ADDENDUM 1 (PENDING DSA APPROVAL)

PROJECT: **Santa Ana College**
 Science Center

DATE: 8/23/2017

DSA File No.: 30-C2
DSA Applications No.: 04-115788
HGA Commission No.: 3584-001-00

A433

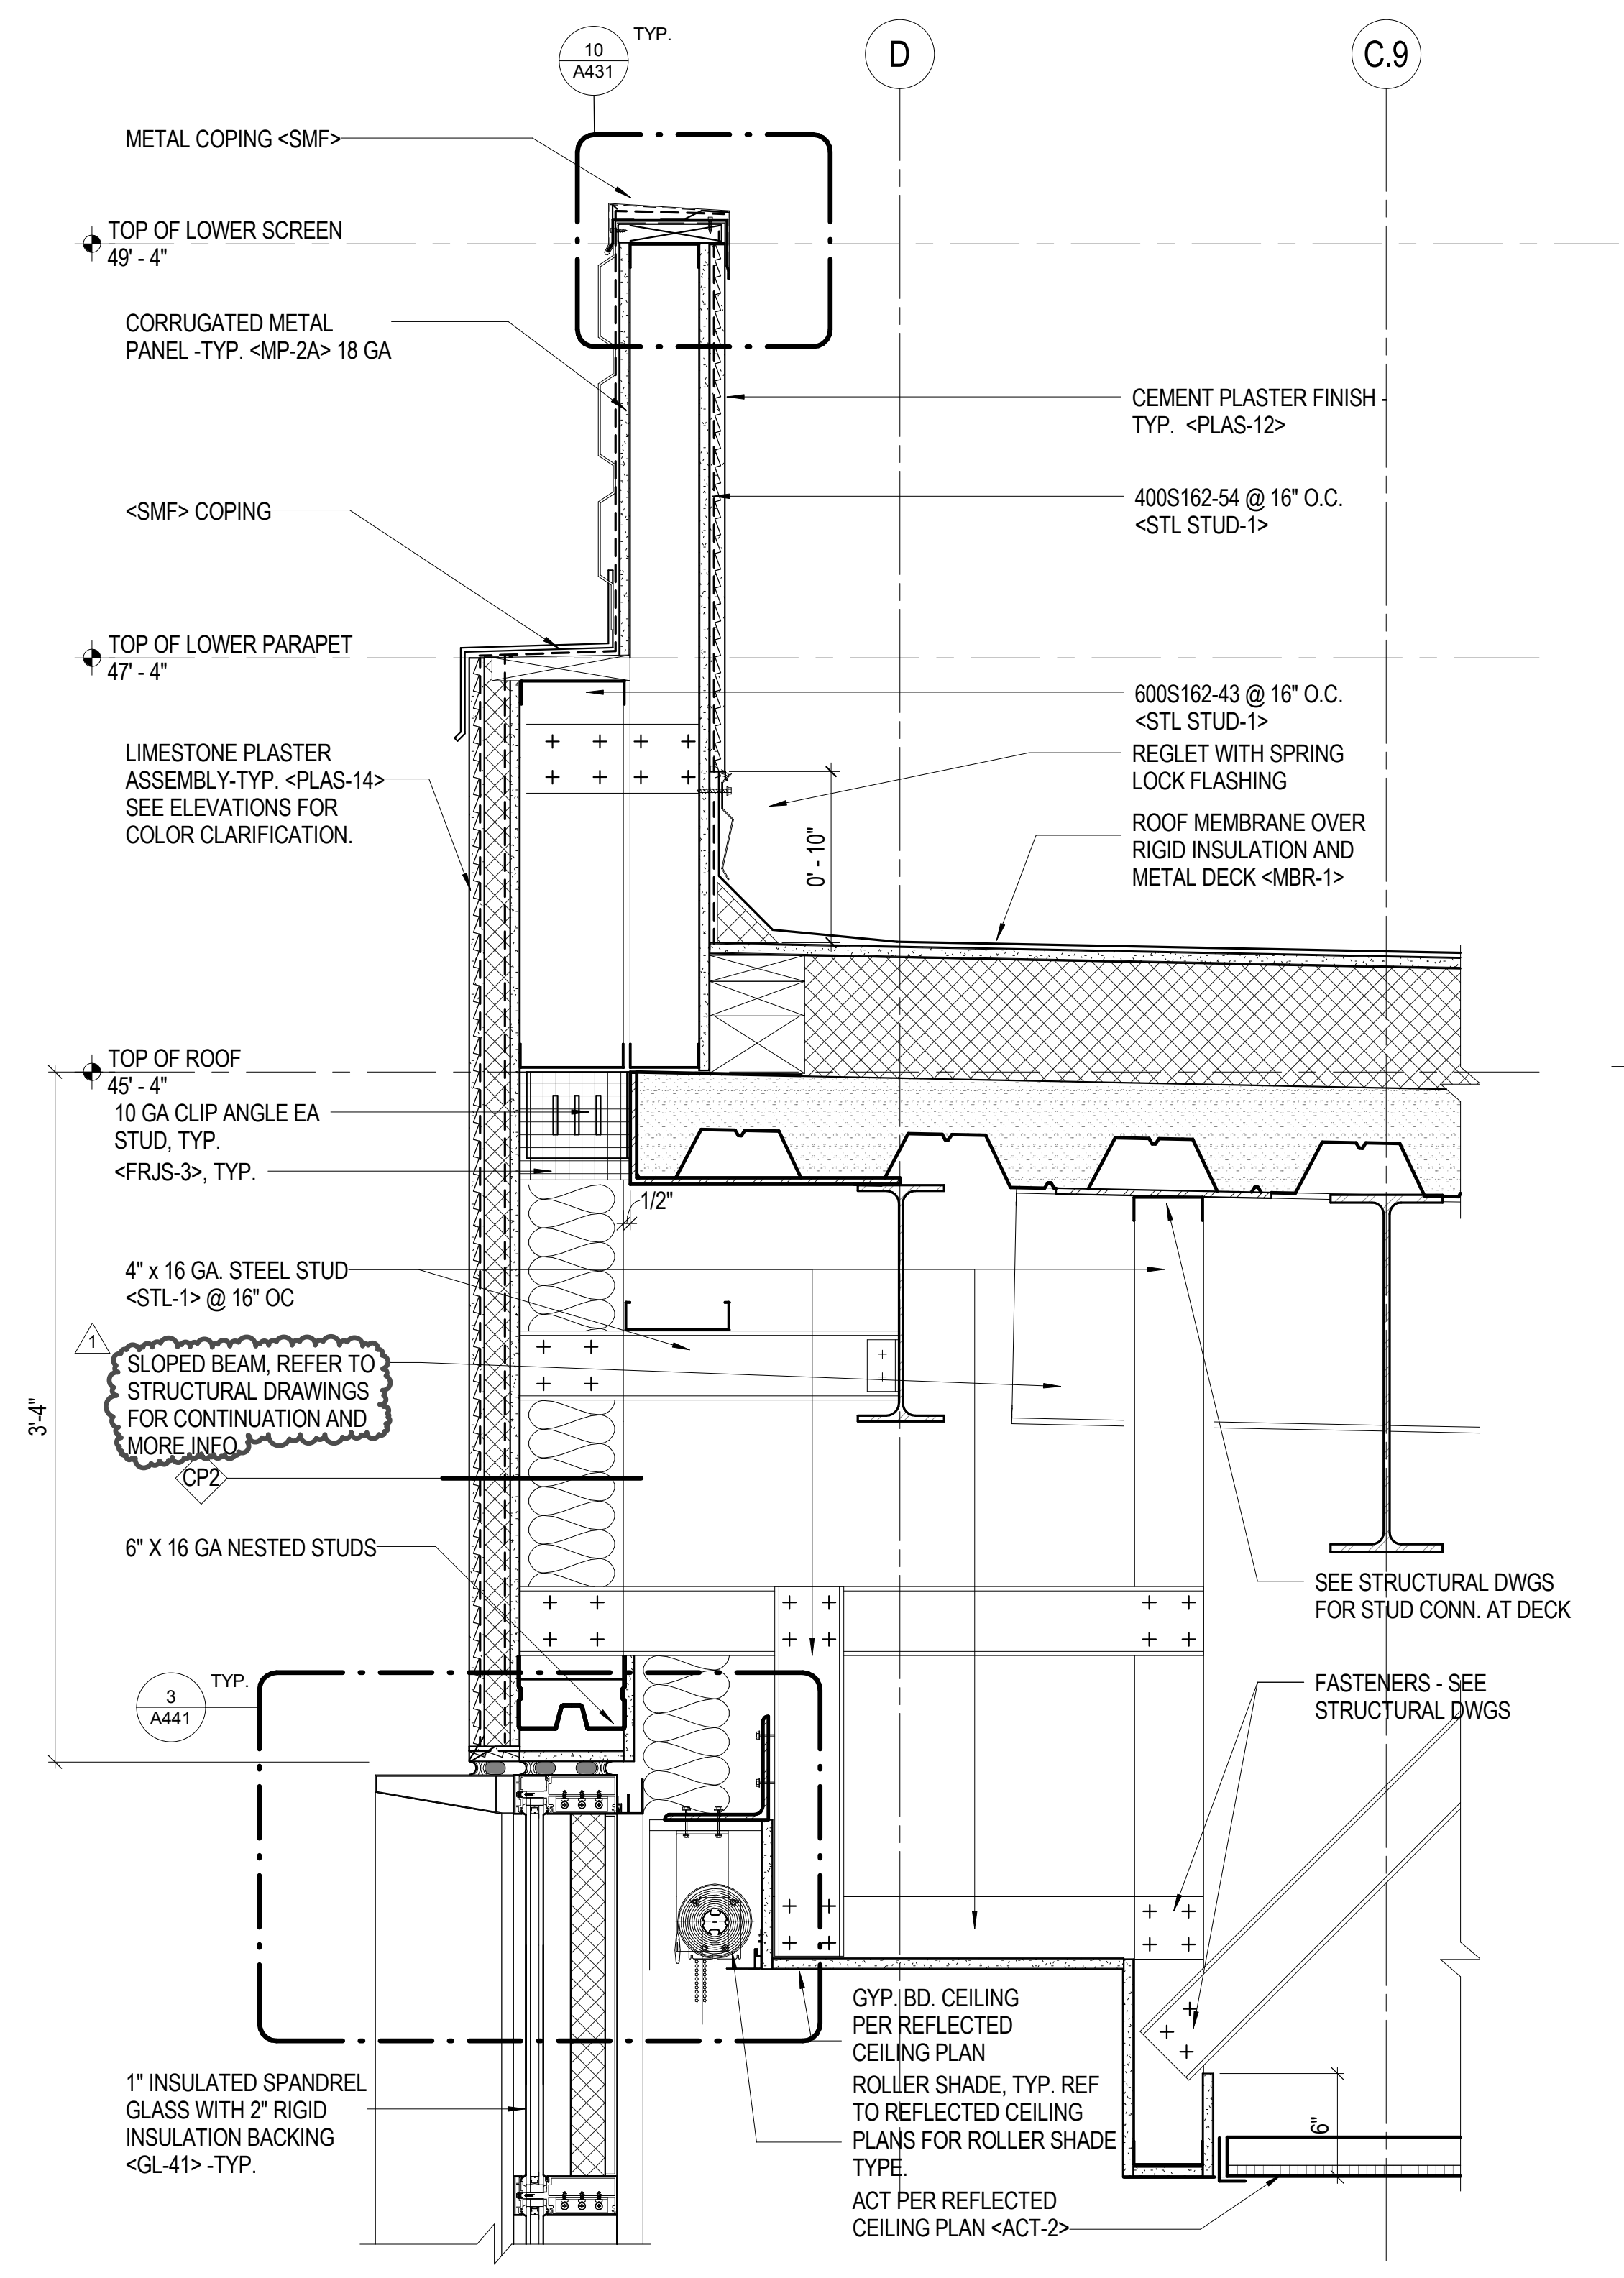
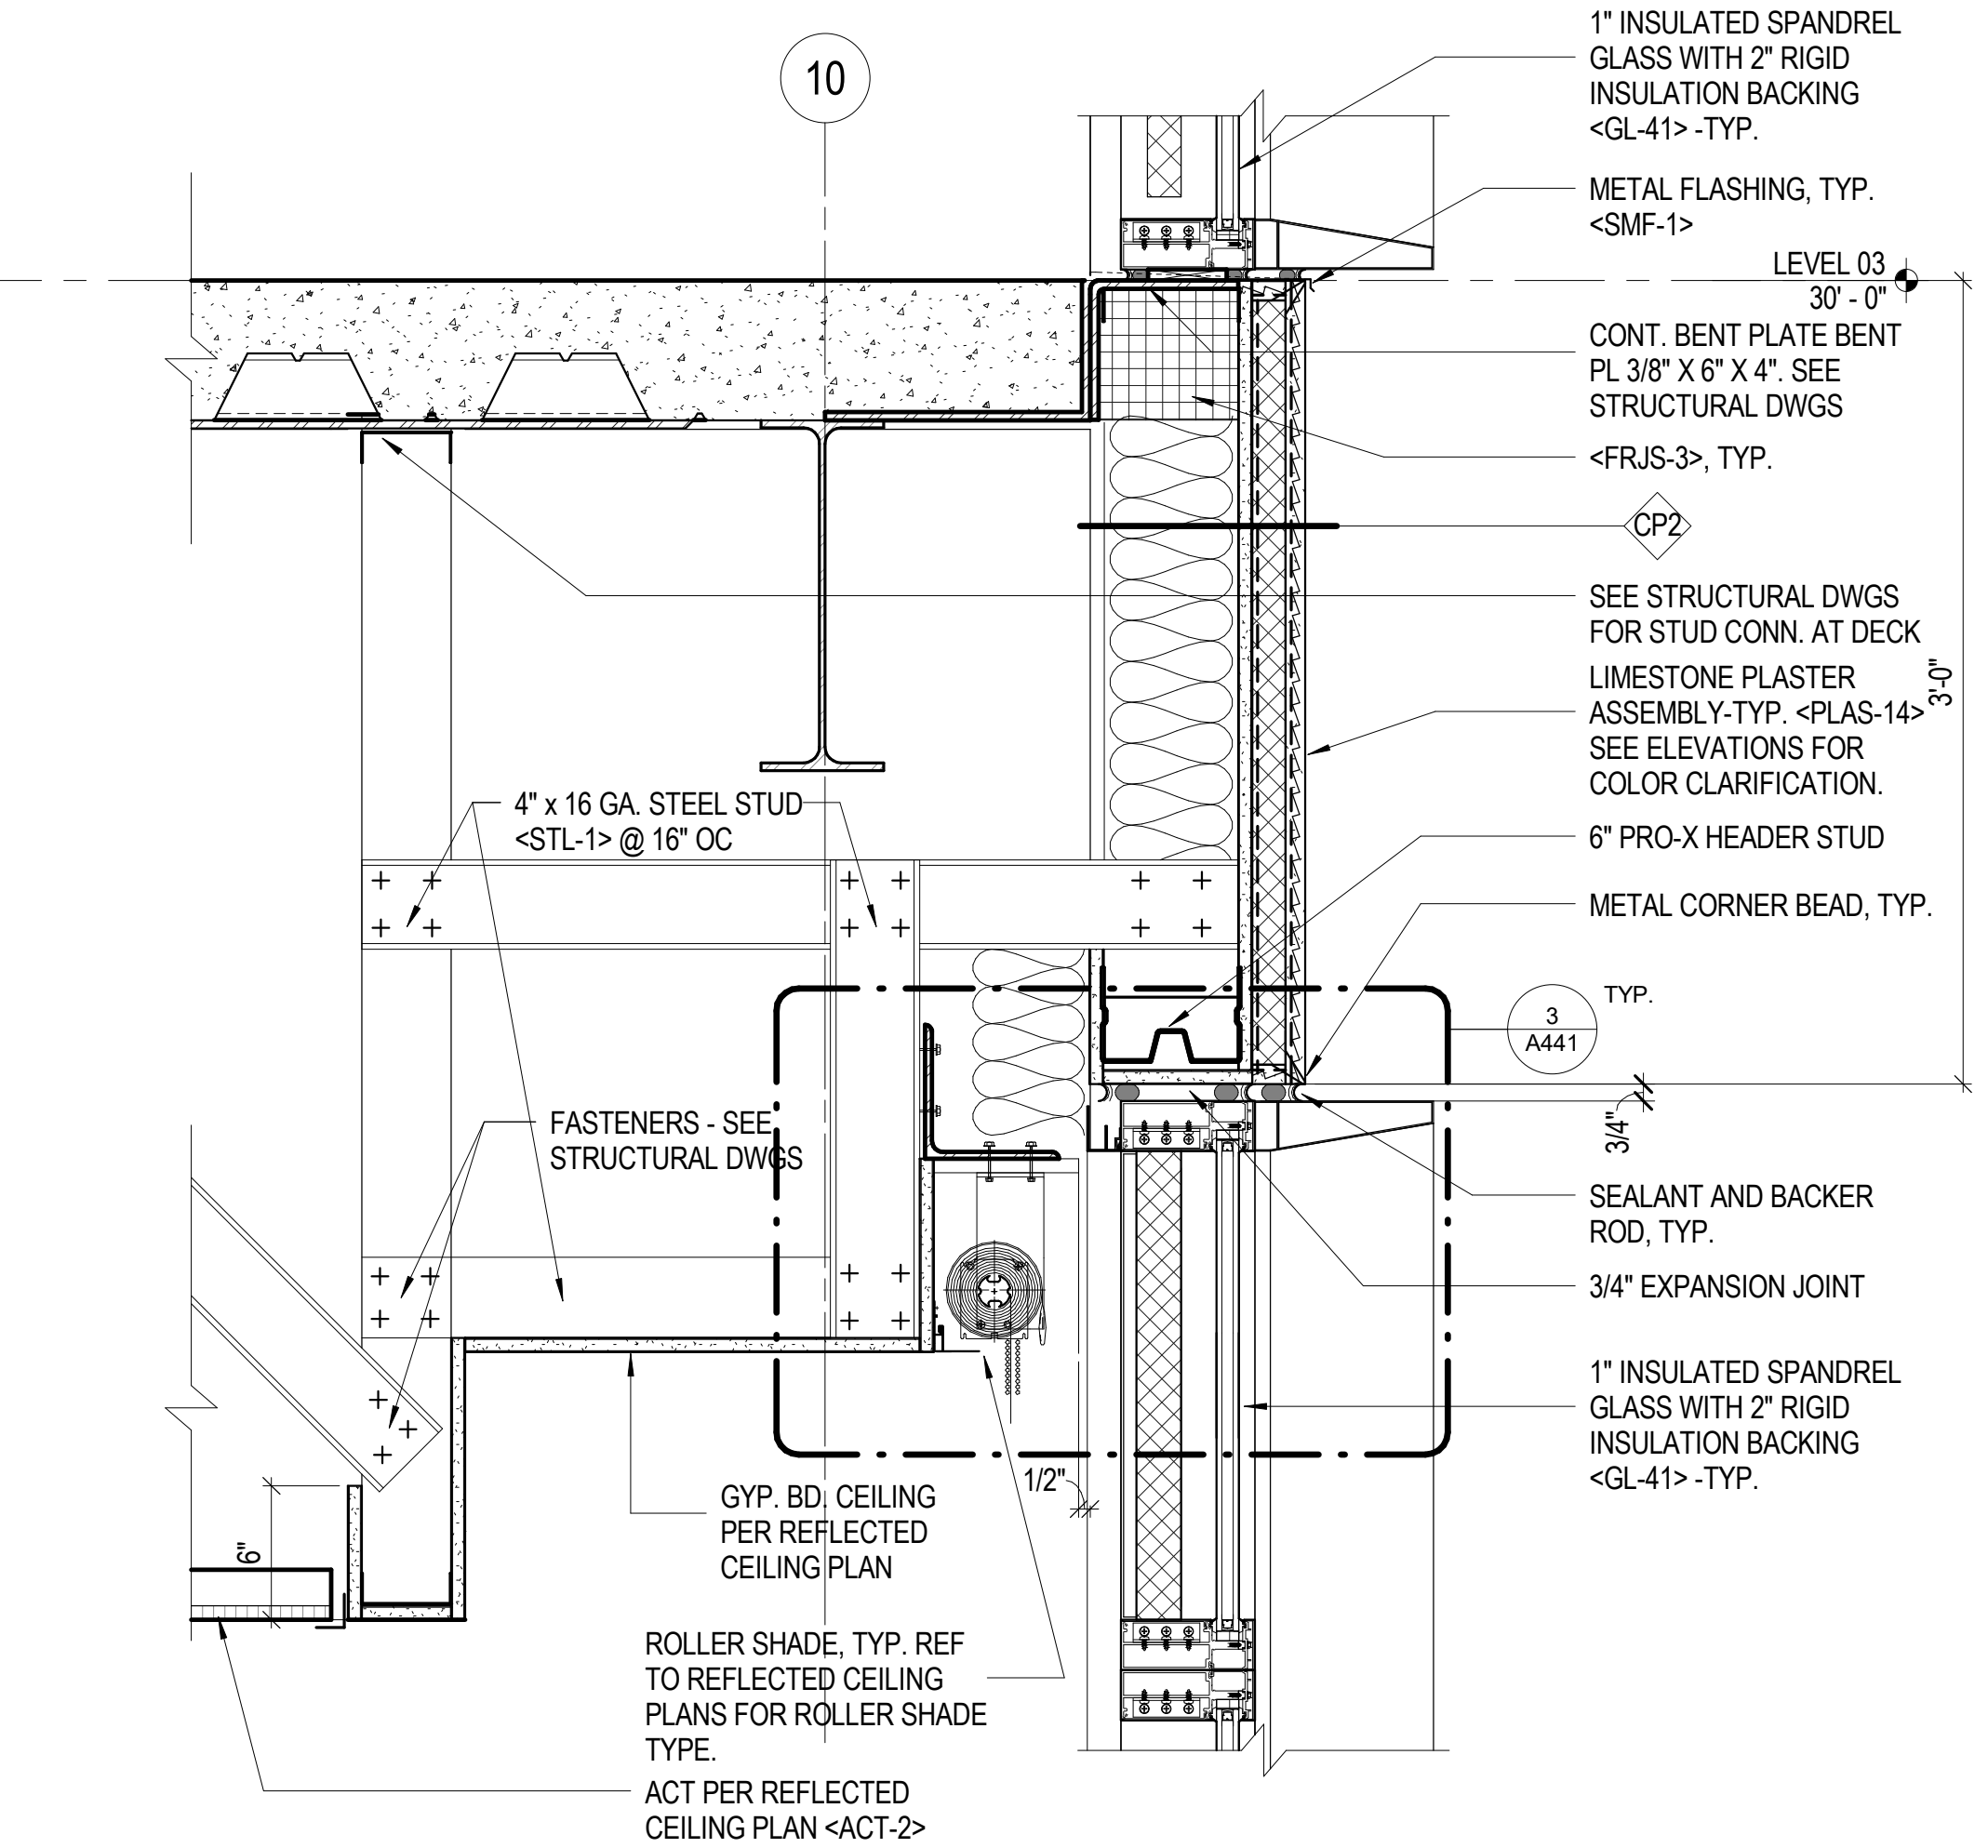
- Gutter removed from roof at north canopy at Details 1.
- Framing at canopy revised to match structural drawings at Details 1 and 4.
